ADDENDUM

Project: Des Plaines Public Library Library Renovation Project Addendum No. **01**

Project No: 13300 Date: 03 September 2015

REQUEST FOR INFORMATION (RFI) RESPONSE

3RD FLOOR
 POWER PLAN - NEW

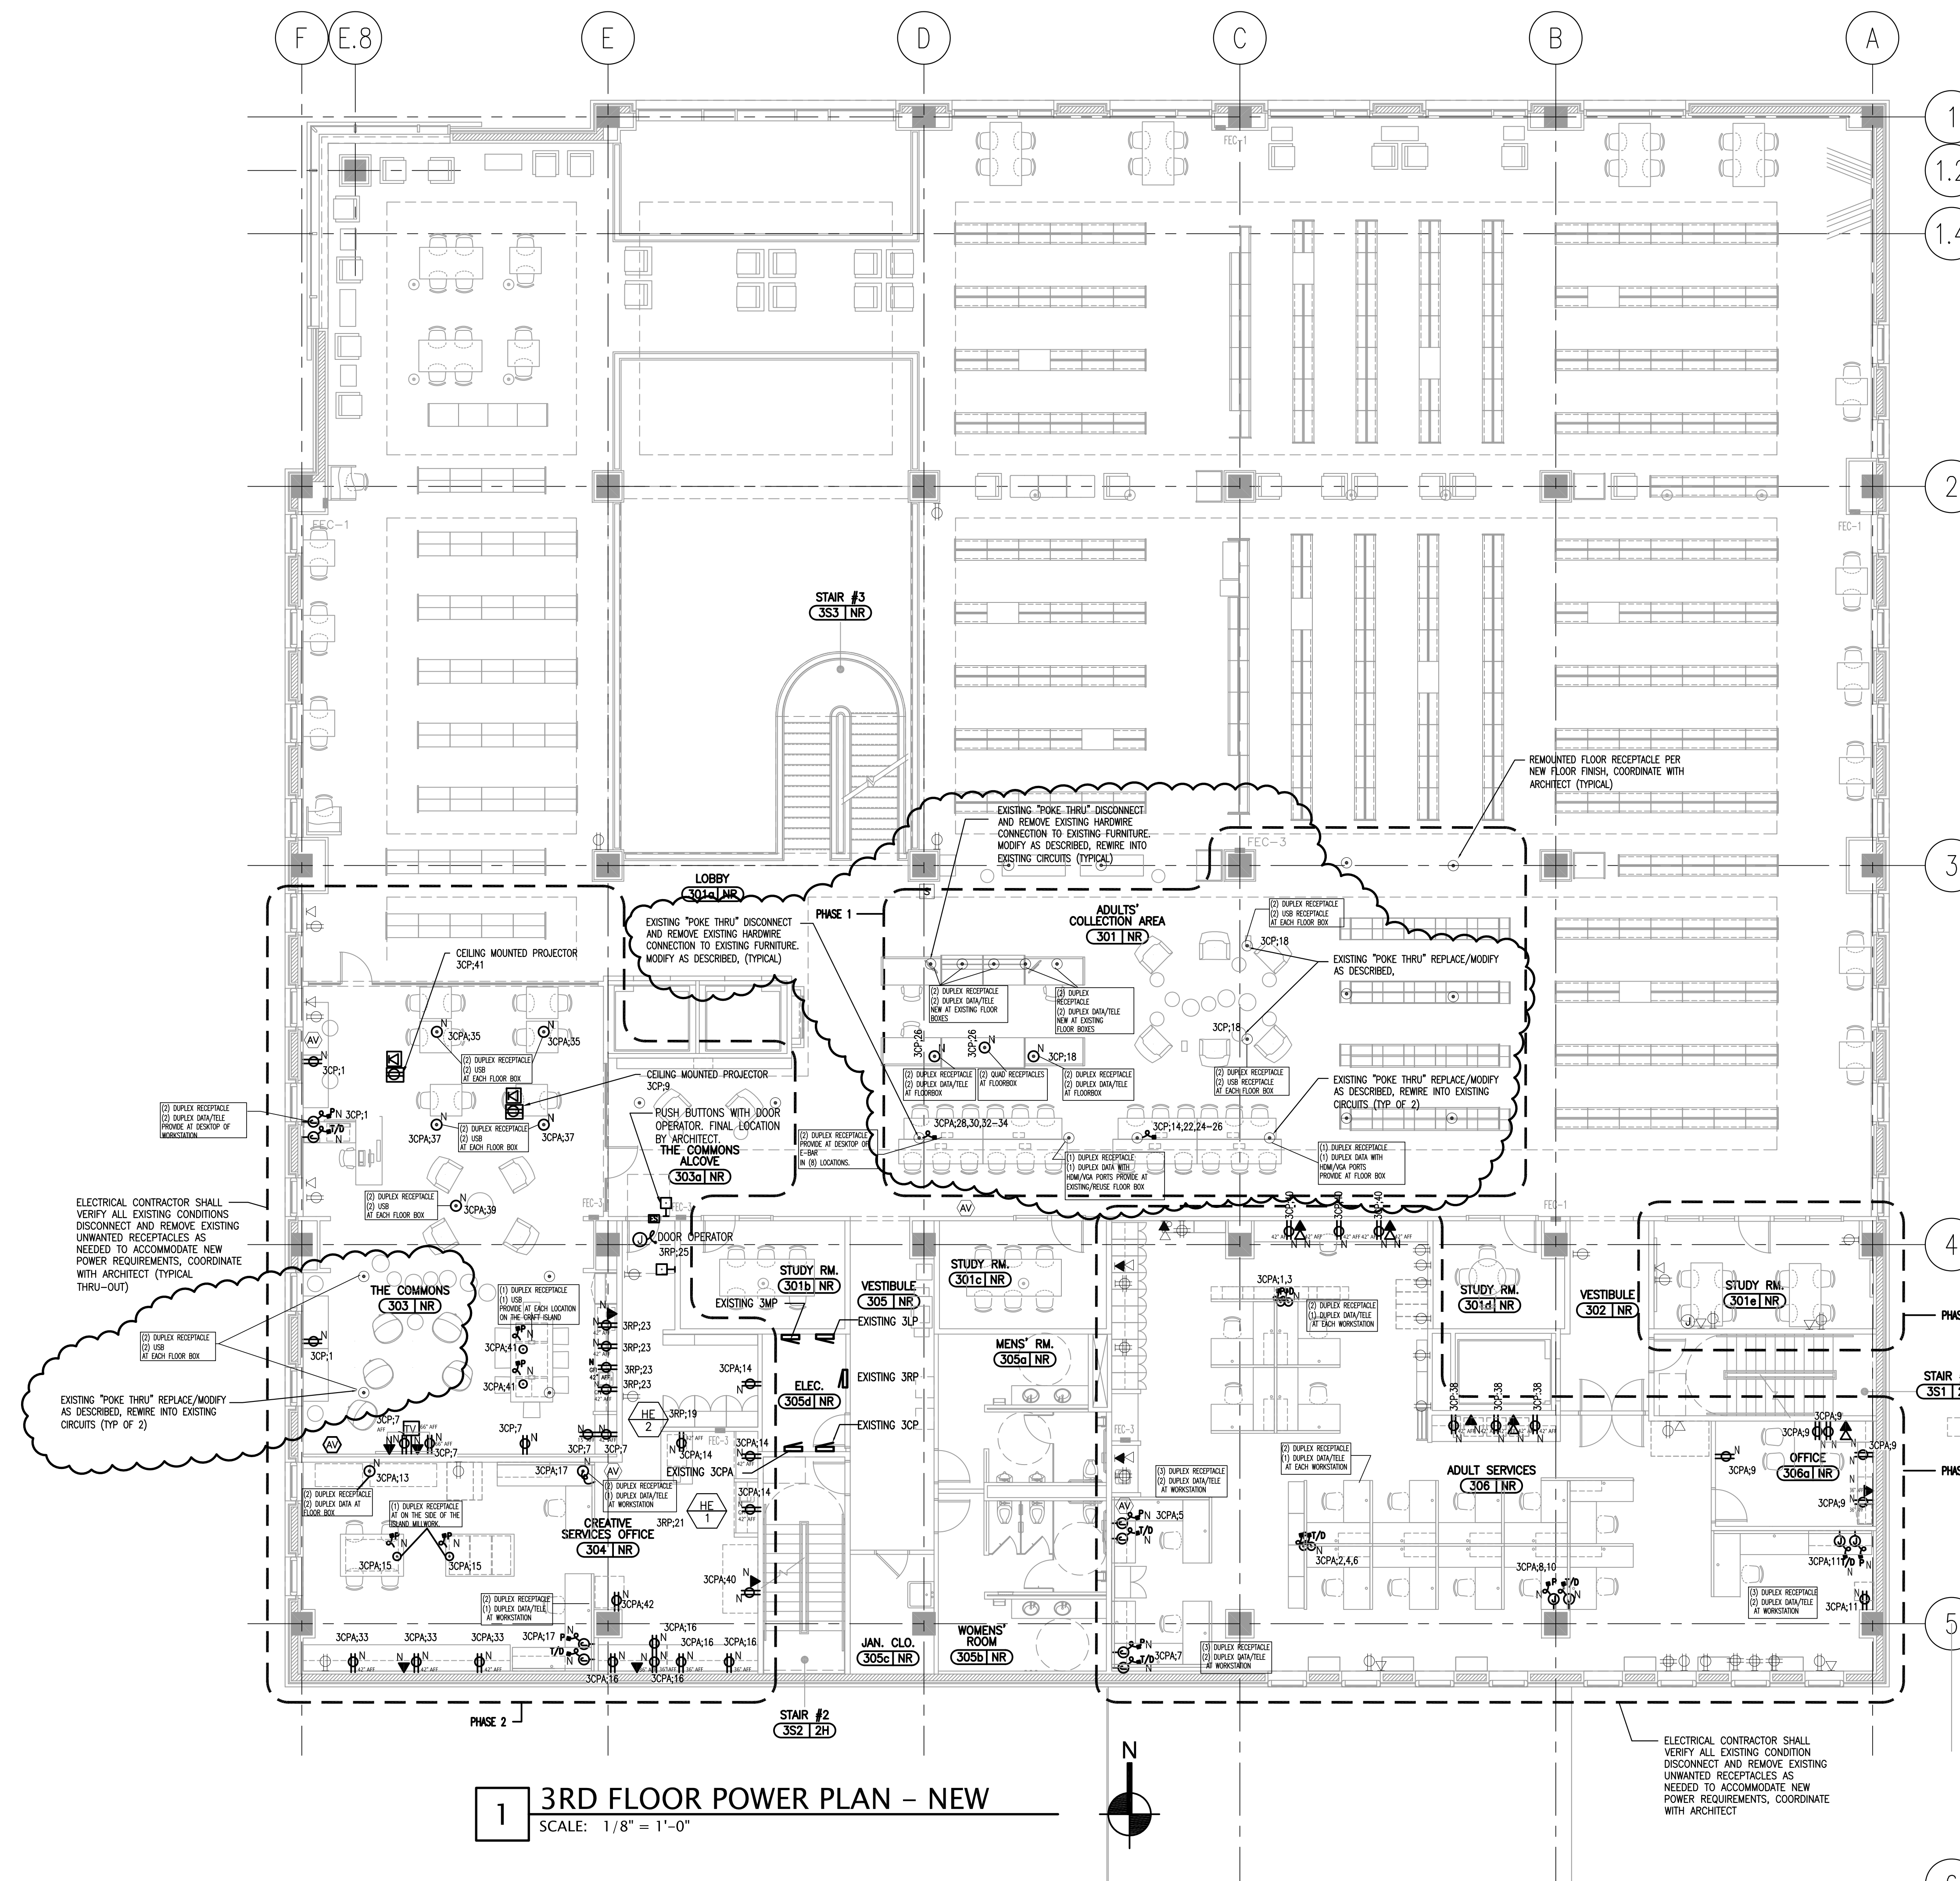
Answer: The "Clear triangle" represents a single Telephone connection.
Refer to the revised Electrical plans as part of Addendum #1.
6. **Question:** On drawing E1.3 room 306 & 306a the clear & dark triangle does this represent 1 voice/ 1 data location? Please clarify.

15. **Question:** On drawing E1.3 Adults Collection area 304, notes for USB, HDMI & VGA, are these by AV contractor and we just install the data is this correct?

Answer: Correct, to be coordinate with owner's Audio contractor
16. **Question:** On drawing E1.3 room 303 shows TV, what cabling is required for this? Is it just 1 RG6 Coax or is this also data with it? Again not on symbols list.

20. **Question:** Drawing E1.3 has a note for the Adult's Collection Area 301 stating (1) HDMI/VGA at desktop. Where do these terminate at?
Answer: There will no longer be a HDMI/VGA at the desktop but at the Floor core. Scope should be coordinated with the Owner's IT Personnel and the AV contractor. A TV monitor will use these connection points and to their network. There are two communication rooms: Room 108e Telecom Room and room 404 Computer Closet (IT Room).

Answer: Yes, Refer to the revised Electrical plans E1.3 as part of Addendum #1.
7. **Question:** Are we just installing locations marked with a N? and others not marked are existing to remain, is this correct?

Answer: TV connection shall be HDMI and VGA

**4TH FLOOR
 POWER PLAN - NEW**

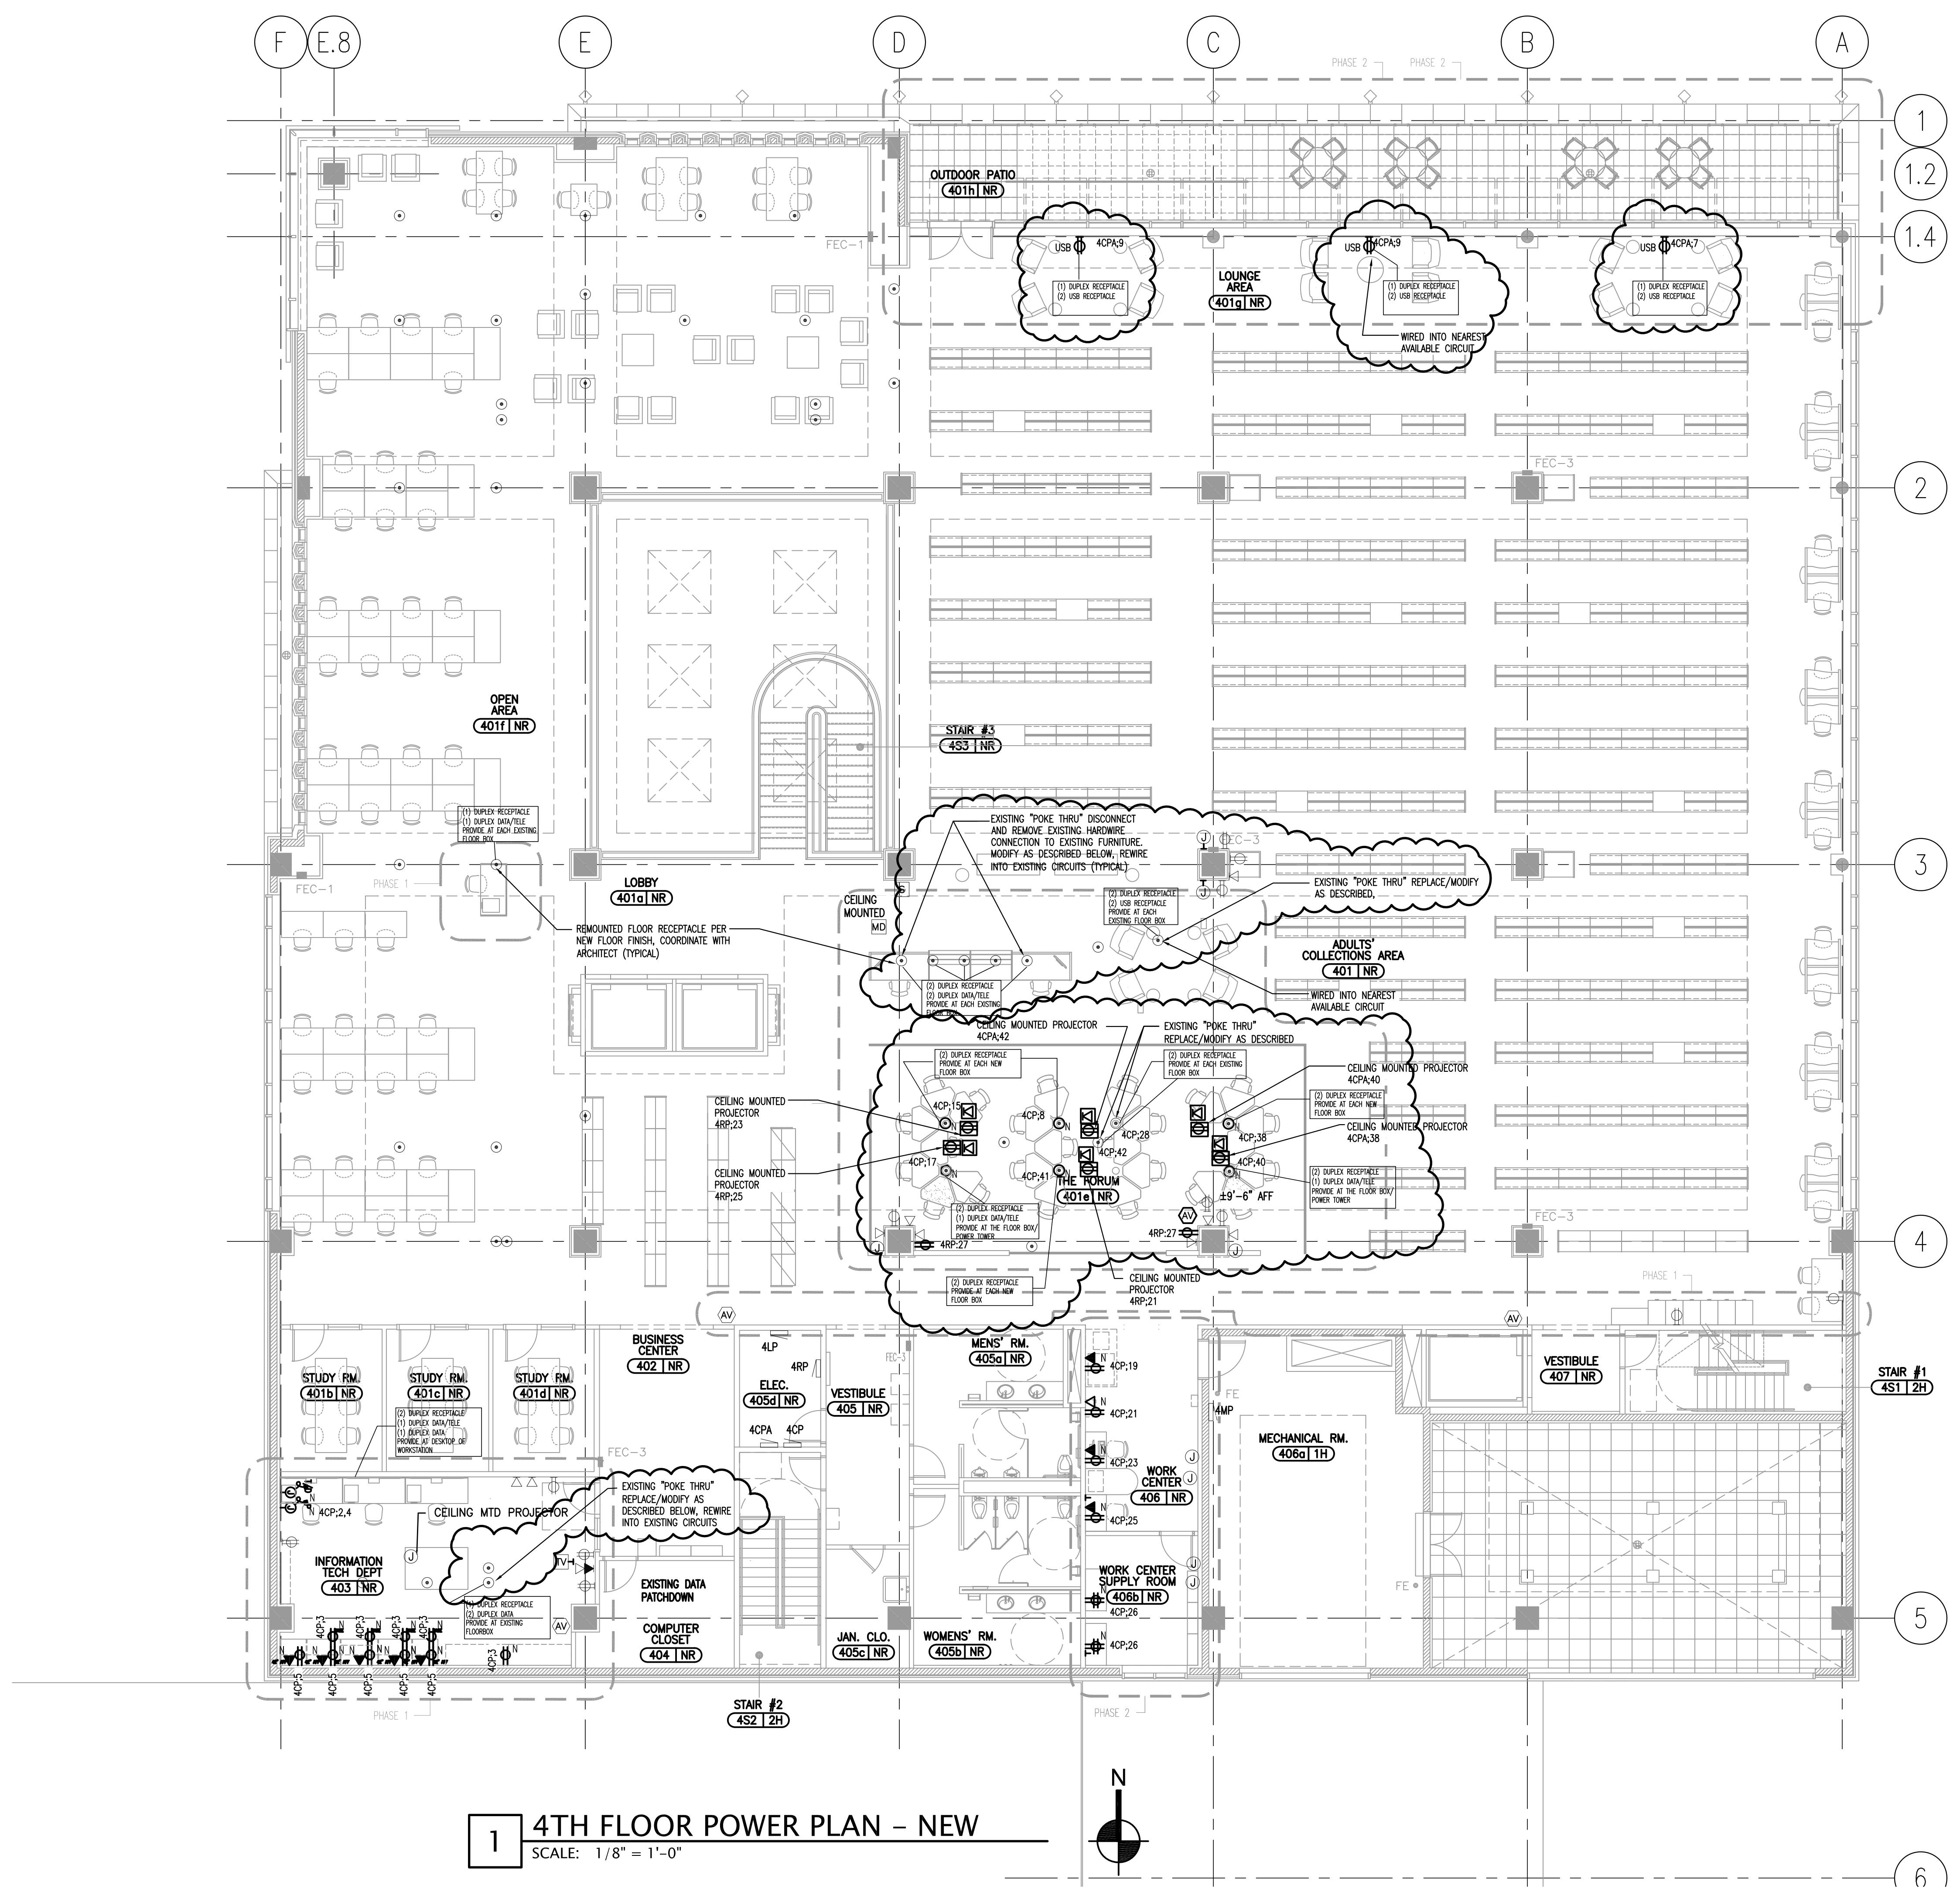
21. **Question:** Drawing E1.4 has a note for the Lounge Area 401g stating (2) USB provided at each new floor box. The symbol shown on the drawing for the USB outlet is a wall mounted device. Please clarify.

Answer: This is a combined USB Power/Electrical receptacle wall mounted. There are no floor box requirements in this area.
22. **Question:** Reference drawing M2.1 Fan-Powered Box and Variable Volume Box specify the new existing controls must be fully integrated into the Library's Building Automation system and that the Mechanical Contractor must engage the Temperature Control Contractor approved by the Library. Who is the manufacturer and installer of the existing controls and who are the Temperature Control Contractors approved by the Library?
